GTC Member Proposed Amendments to the Girdwood Trails Master Plan Jan 18 2022.
Proposed changes may not be addressed in the order shown.

April 2022 Report Girdwood Trails Committee

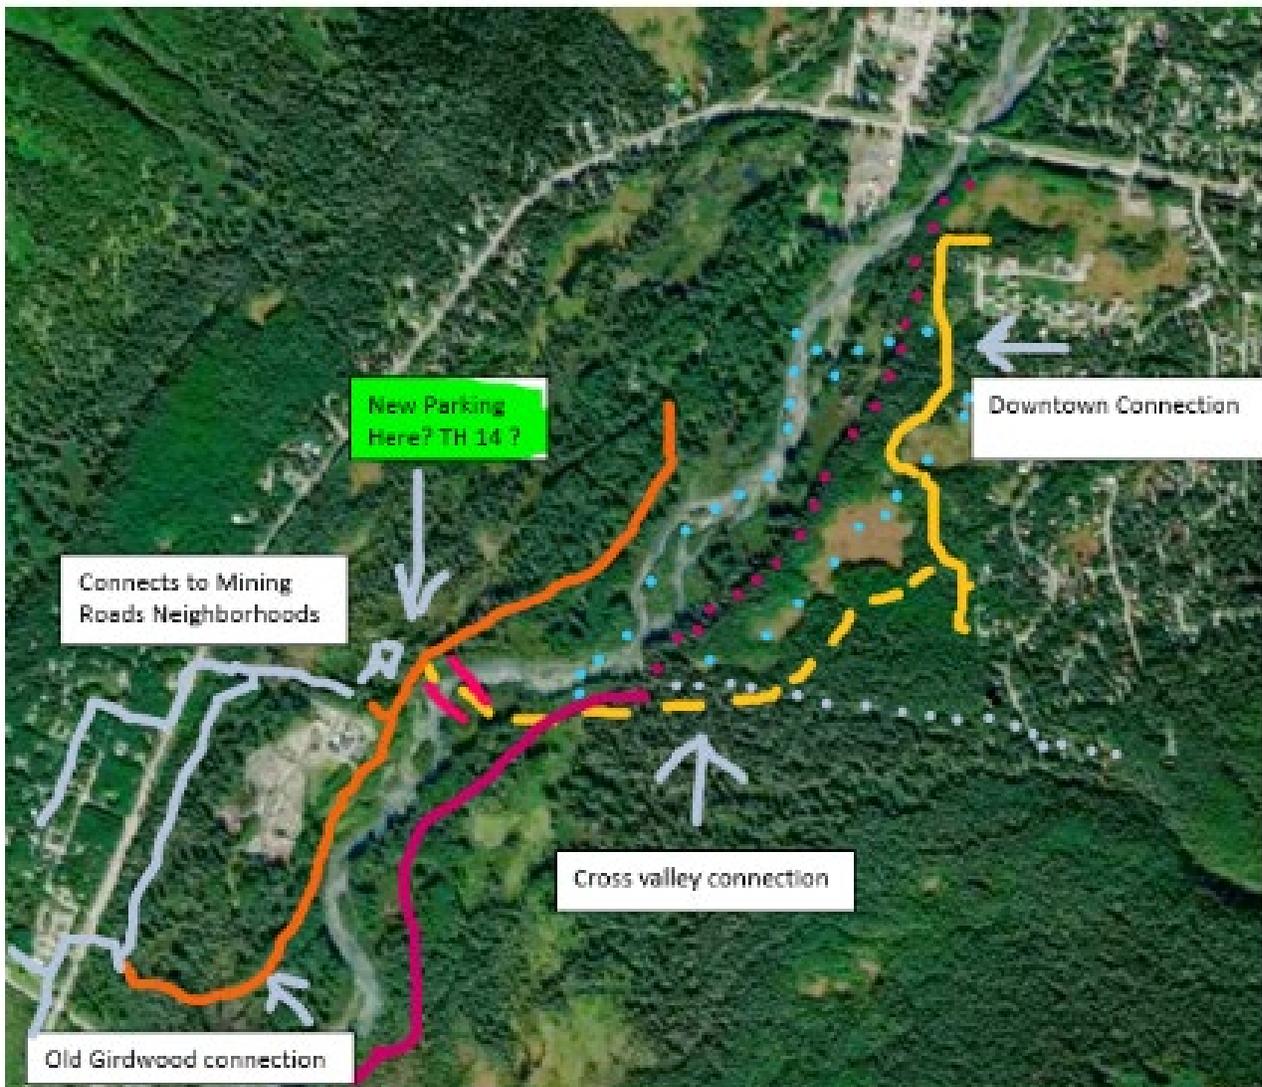
Proposed Motion: Add to the draft plan a new class 3 trail traversing parcel 6-036 and other nearby lands generally following the route that is indicated on the attached map.

Proposed Motion: Add to the draft plan a new site to locate bridge 1. Remove from the draft plan the old location of bridge 1. Select the new location of bridge 1 to correspond with the southern termination of the trail described in motion 1. (eg Amendment 11)

Proposed Motion: Add new trailhead parking #14 near the southern termination of the trail described in motion #1. (eg Amendment 11)

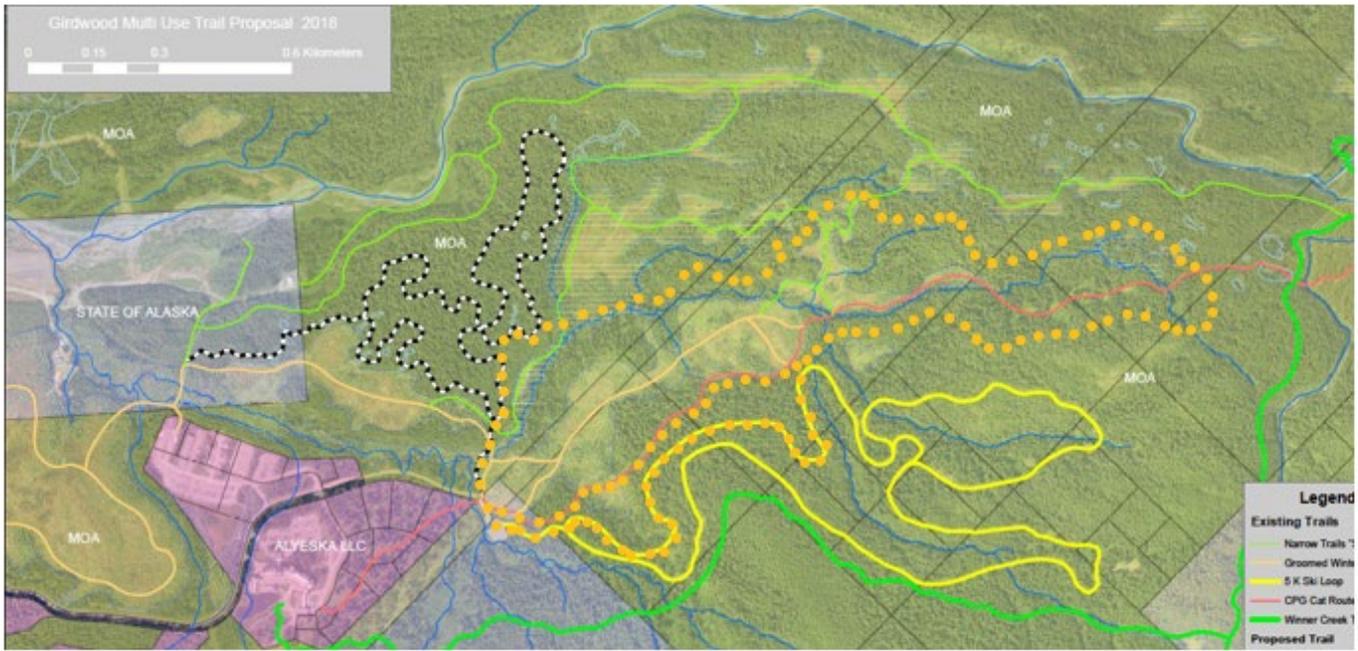
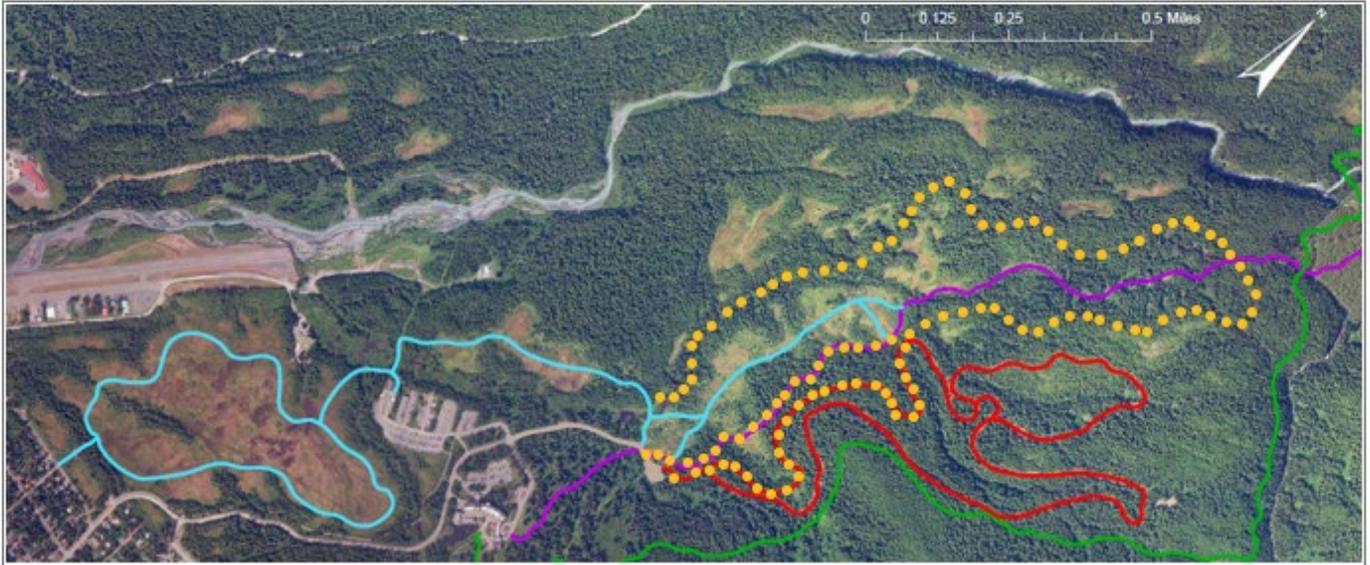
Proposed Motion: add back an Upper Valley Connector from the Forest Loop to the CPG CAT Track near the CAT Track Bridge. (see maps below)

While the exact area of the connector trail can be discussed in the future, showing a Class 4 year-round looped trail system is congruent with the community survey results and Girdwood Master Plan comments. The trail originally included in the plan was removed because people commented the space was crowded. Yet, if you look at the summer map the GTC created (shown below), no summer trails exist in this area. This area has been repeatedly zoned and defined as Open Space and Recreation Zone. In 2006, HLB commissioned a trail feasibility study to determine where to add 20 Kilometers of multi-use trails to this area. I agree that the primitive trails should remain primitive, but I disagree with this proposed primitive area covering all of the uplands of the Girdwood valley west of the CAT track, thus prohibiting a future multi-use trail system development that includes summer or winter bike travel.

PT1 Expansion to Wagon Trail

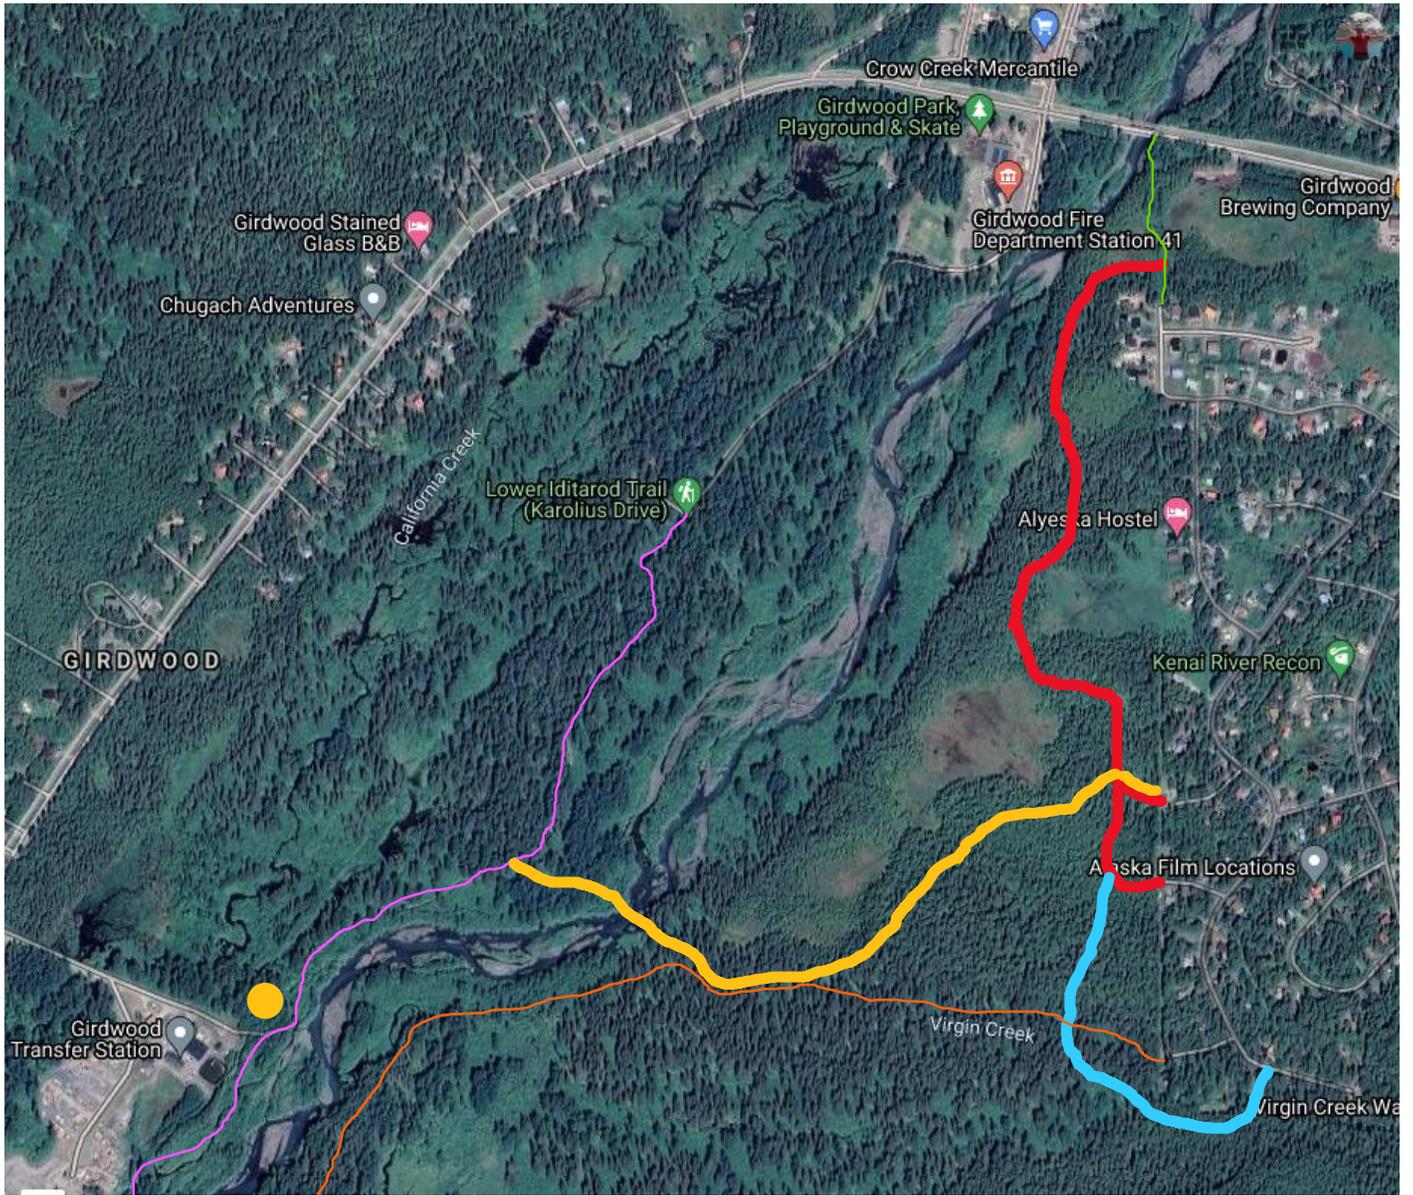
Expand PT1 east to include Wagon Trail.

Recommend adjusting the boundary of NS1. The eastern boundary should extend and include Wagon Trail.

- Wagon Trail is a Class 1 trail and would be a good landmark to delineate the eastern boundary of PT1.
